275 & 277 GREENWICH HIGH RD. SE10 8NB
EXISTING SECOND FLOOR PLAN
1:50 on A3 26may21 dwng 4

275 & 277 GREENWICH HIGH RD. SE10 8NB
EXISTING & PROPOSED REAR ELEVATION 1
approx 1:50 on A3 3feb22 dwng 7

275 & 277 GREENWICH HIGH RD. SE10 8NB
EXISTING & PROPOSED REAR ELEVATION 2
approx 1:50 on A3 3feb22 dwng 8

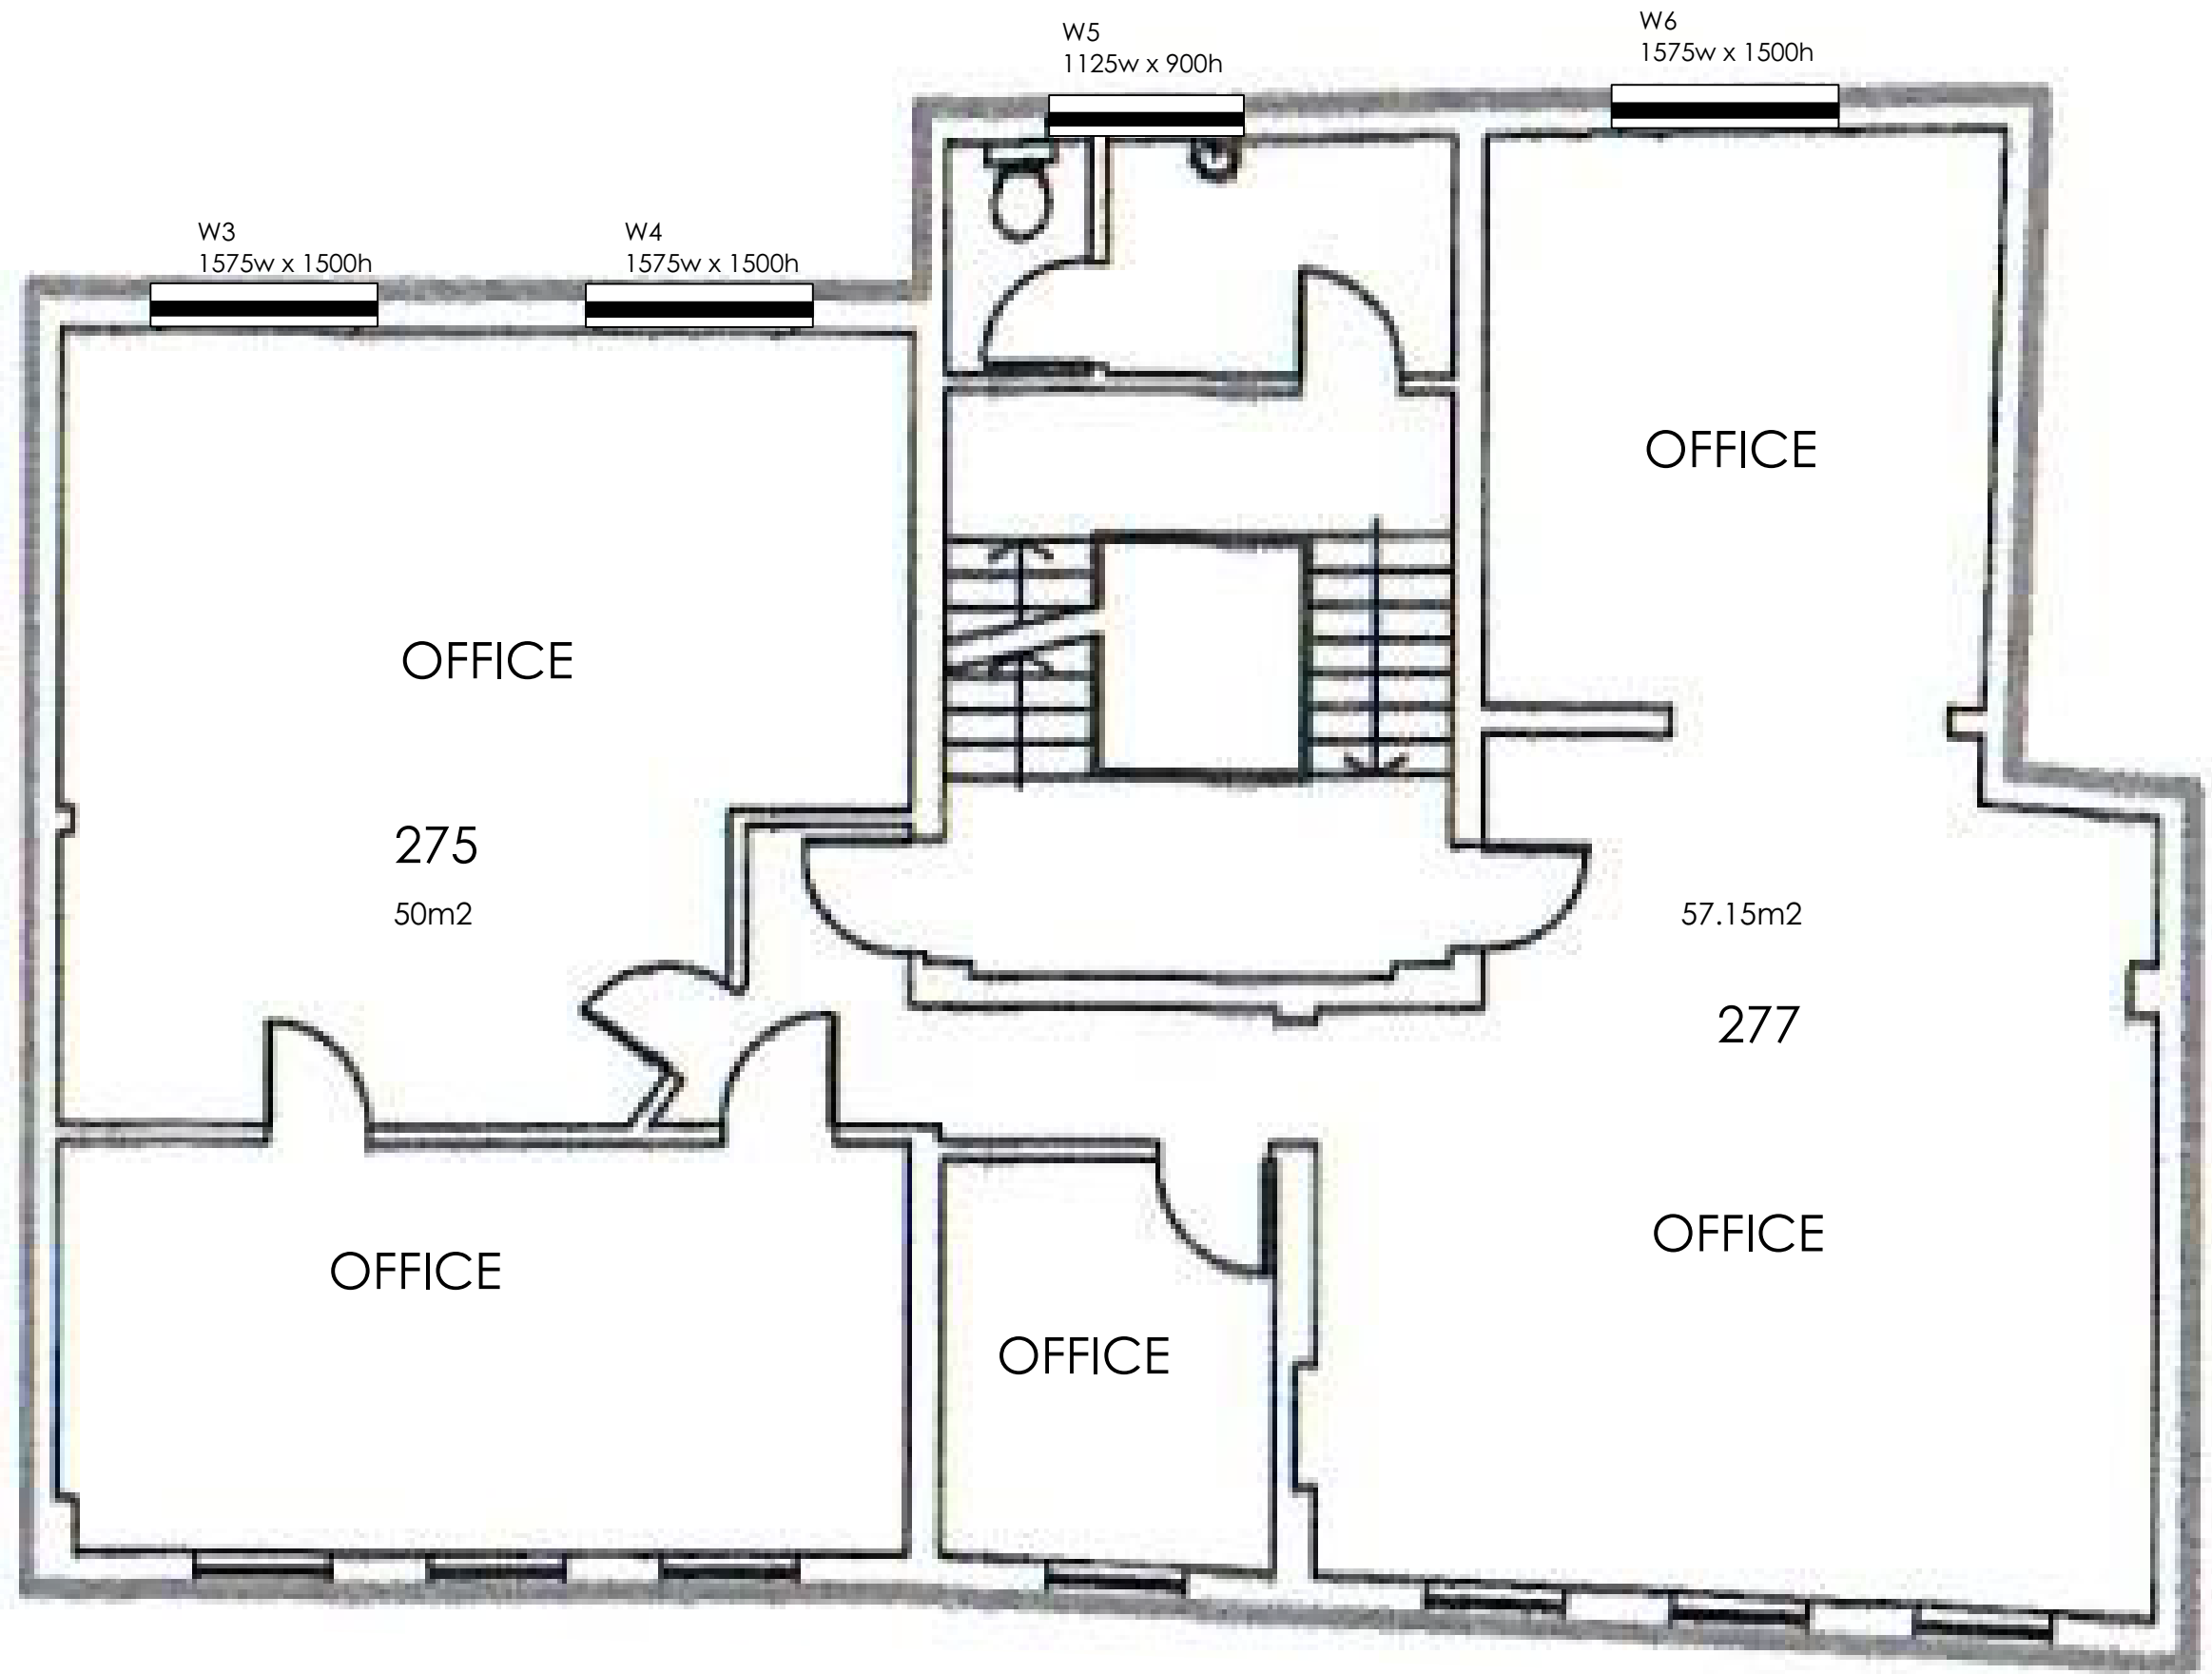
CRITTALL WINDOWS changed to aluminium narrow framed powder coated dark grey with the same configuration of casement, fanlight & fixed windows

CRITTALL WINDOWS changed to aluminium narrow framed powder coated dark grey with the same configuration of casement, fanlight & fixed windows
